ACER'S REPLY

TO ERAA 2024 CALL-FOR-EVIDENCE ON PRELIMINARY INPUT DATA

Figure 2. Changes in export and import capacity (2026=100%) for indicative 4 Member States (MSs) of the CORE region, for each target year in ERAA 2024.

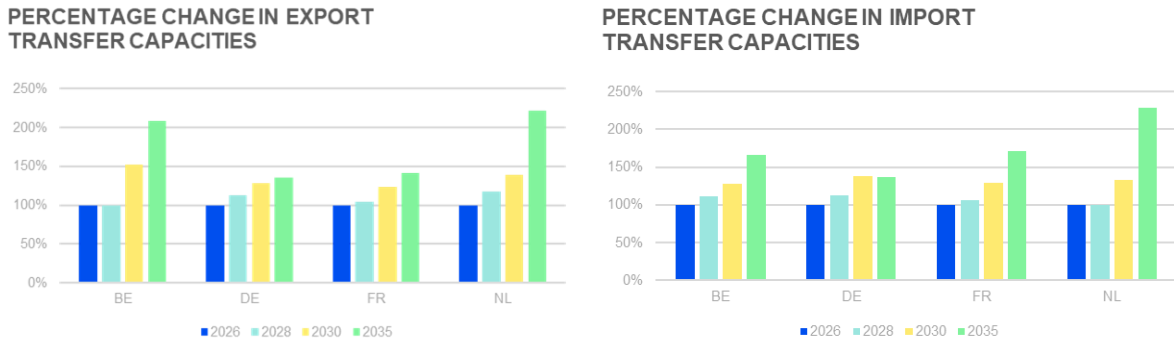
Similar to ERAA 2023, the relative year-on-year increases shown in Figure 2 indicate that infrastructure developments have a considerable impact on the amount of cross-zonal capacities for the CORE region over 2026-2035. The Net Transfer Capacities provided for ERAA 2024 show an even more significant increase of capacities across the target years, even exceeding 200% increase for some Member States (BE, NL), as shown in Figure 2. Therefore, it is of paramount importance that in ERAA 2024 flow-based domains are derived for each target year, considering the substantial increase of cross-zonal capacities. Nevertheless, ACER lacks information to verify whether the Net Transfer Capacity values provided are correct in absolute terms.

Figure 3. Export transfer capacities for the Netherlands and Denmark for the target year 2035.

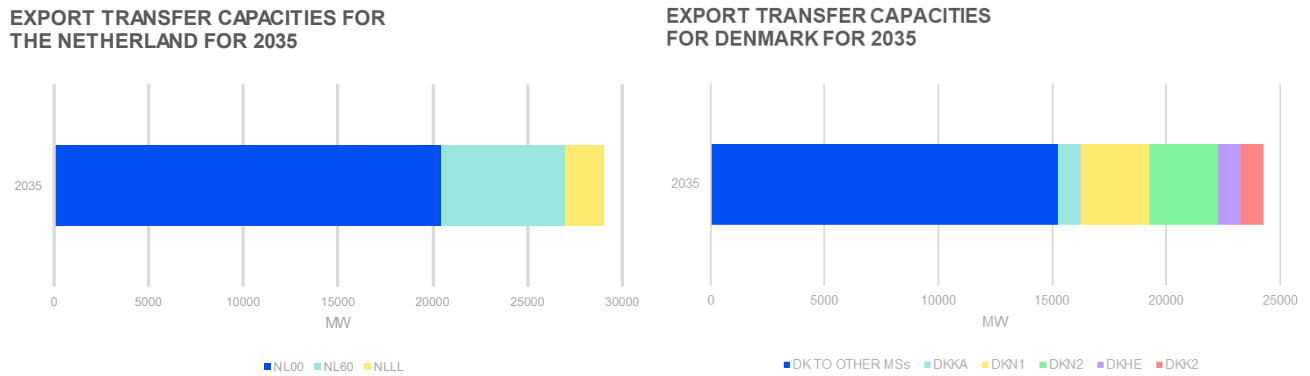
In addition, in the ERAA 2024 preliminary input data, new market nodes have been introduced for certain Member States, such as the Netherlands (market nodes NL60, NLLL, NLA0) and Denmark (market nodes DKKA, DKN1, DKN2, DKHE, DKK2) without further information in the input data. This creates difficulties and confusion for stakeholders when evaluating the transfer capacities. The additional transfer capacities introduced by these market nodes result in substantial increases to the transfer capacities, if, for example, these are aggregated, as can be seen in Figure 3, which shows the export transfer capacities for the Netherlands and Denmark for the target year 2035. Furthermore, Net Transfer Capacities are provided for each border and direction twice from both sides of the border, and most of these Net Transfer Capacities differ, creating confusion as to which Net Transfer Capacities will be considered in the ERAA 2024.

Conclusion: It is crucial to consider the network developments in ERAA 2024 by properly identifying flow-based domains for each target year in the ED. Furthermore, for increased transparency, more information should be provided regarding the transfer capacities and the definition of the newly introduced market nodes.

Figure 4. Comparison of the consulted NTC values with actual cross-border physical flows in 2023.

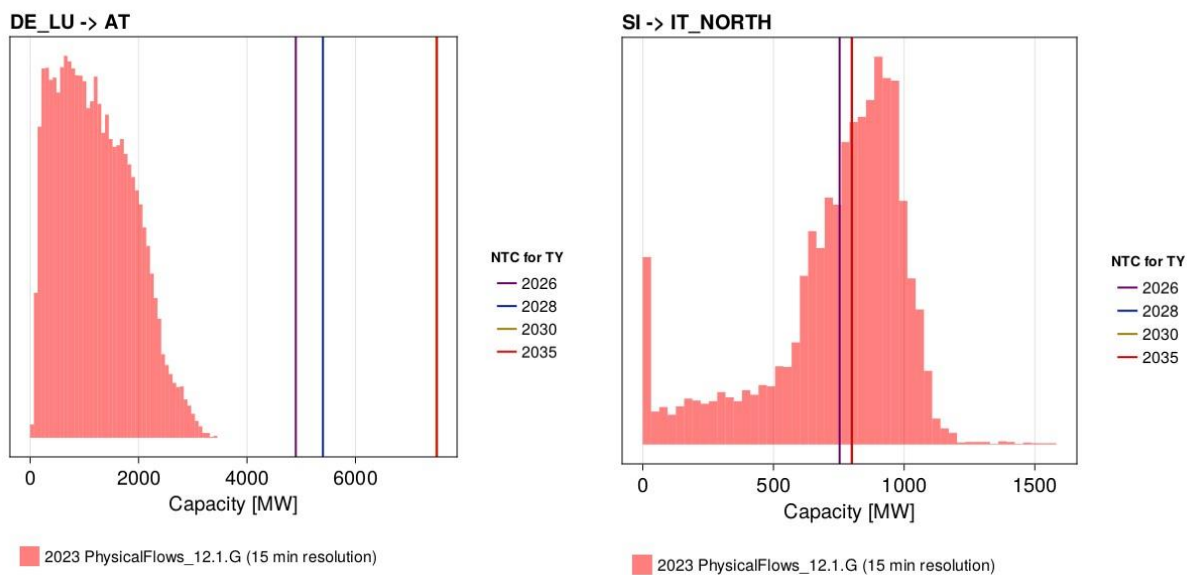
In a bid to evaluate the Net Transfer Capacities submitted by the TSOs, ACER compared the values border per border with the actual physical flows realised in 2023. By comparing the distribution of cross-border flows throughout the year and the consulted Net Transfer Capacities,¹ the analysis showed that the large share of the NTCs seemed to reflect future network development and convergence towards the 70% requirement. However without additional data published in the consultation this cannot be verified.

Nevertheless, outliers were also identified illustrated by Figure 4. In one case (border between Germany and Austria), it shows an increase of the Net Transfer Capacities submitted for ERAA 2024 (vertical lines) compared to the distribution of physical flows (pink area in the Figure). Additional information regarding the network development is essential to understand which factors explain these differences. In another case (Slovene border with the Italy North bidding zone), Net Transfer Capacities for all ERAA 2024 target years are lower than physical flows in 2023.

Conclusion: It is critical that the CORE region TSOs provide accessible and comprehensible information on the NTC-calculation methods employed. Furthermore, including in the consulted dataset a list of network development projects considered/removed in the assumptions will further strengthen transparency. ENTSO-E should review and consolidate the data set with particular attention to outliers.

Figure 5: Percentage of explicit DSR in peak demand according to TSOs' best estimates for target year 2026.

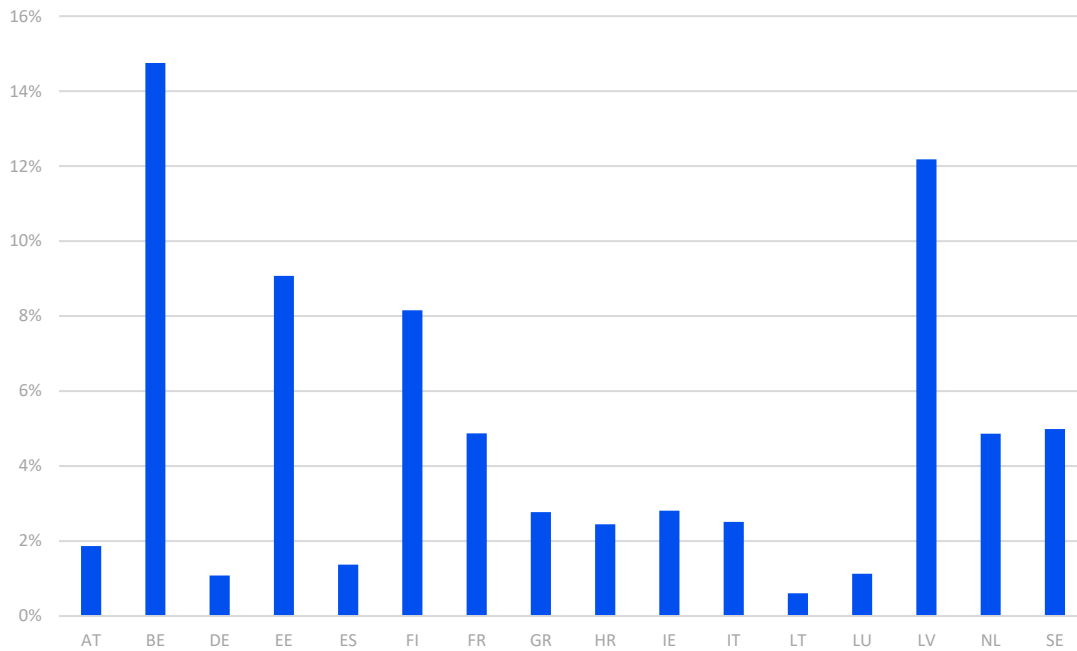
The TSOs' estimates of DSR levels differ, based, among others, on national characteristics. For comparability, ACER assessed the level of exogenous explicit demand-side response vis-à-vis the projected average⁵ peak demand in the respective Member State⁶. Figure 5 shows the ratio between the exogenous DSR assumption for TY2026 and the corresponding peak hourly demand (both in MW). Values vary between Member States, with several Member States projecting that more than 8% of the domestic peak demand in TY2026 could be covered by DSR, while estimates in other MSs are lower or unavailable (as indicated in Section 3.13.2). Further information on what the estimates by TSOs represent (e.g. current DSR volumes, capacity mechanism contracts) would be beneficial and could provide context to understand the differences.

Conclusion: Given the variety in the level of explicit DSR estimates across EU MSs, it would be beneficial if the dataset included information on what the different TSOs' DSR estimates represent and what assumptions they are based on.

Figure 6. Difference (in %) between projected total demand for 2026 and actual demand in 2023

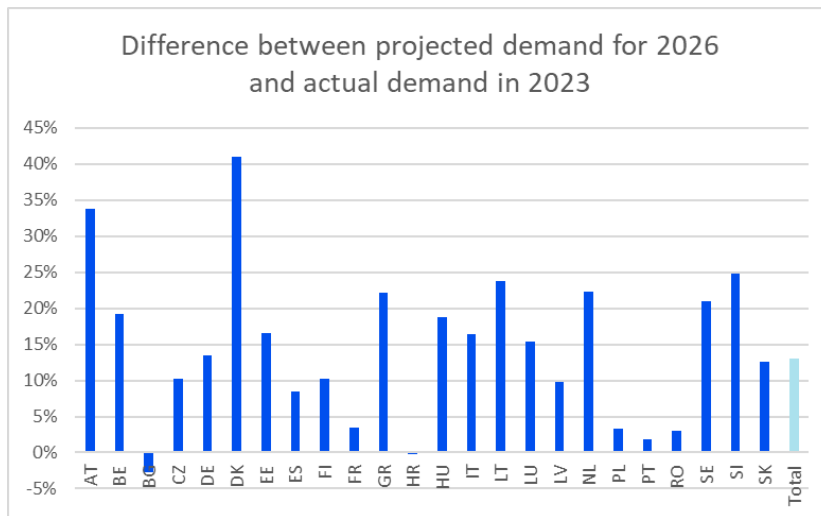
ACER compared the total demand projected by the TSOs for 2026 (the target year closest to the present) and compared it with the actual demand in 2023⁸. Figure 6 shows the comparison per Member State. Figure 7 translates the difference into the implied annual demand growth. To reach the 2026 estimates, demand in some Member States would have to grow at an annual rate of up to 12% every year from 2024 to 2026.

Figure 8. Implied peak demand growth from 2023 to 2026 and actual peak demand growth from 2019 to 2023.

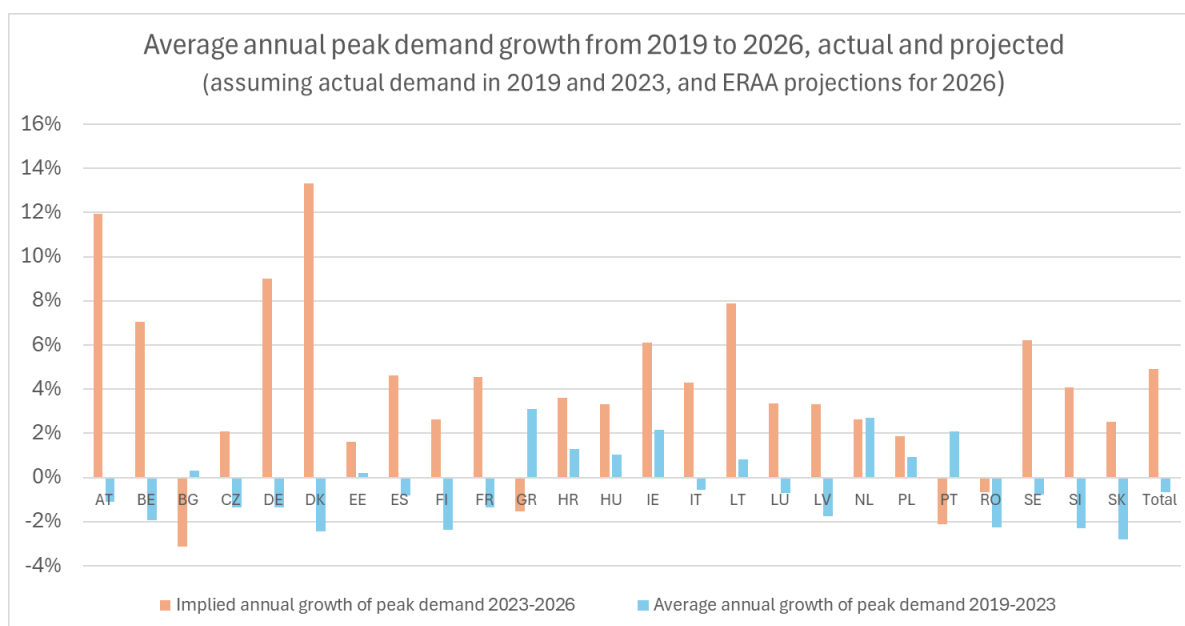
ACER made an analogous comparison for peak demand. Similar trends as those described in Section 4.1 can be observed. Figure 8 shows the implied growth rate which peak demand would have to follow from the actual values in 2023 in order to reach the values projected for 2026.

ACER received information from the Austrian NRA that while demand values for 2026, 2028 and 2035 seem implausible, the high increase in peak and total demand for 2030 could be a consequence of Austrian decarbonisation plans regarding the heat, mobility, and industrial sector (including plans for the transition of significant industrial users to the electricity sector)¹⁰. Such contextual information cannot be derived purely from the consultation dataset.

Conclusion: ACER suggest that the datasets provided by the TSOs are accompanied by “country comments” – similar to the final ERAA report – that are concise textual information noting the key impacting factors considered in the demand projection analysis, and which would help understand the most prominent trends.
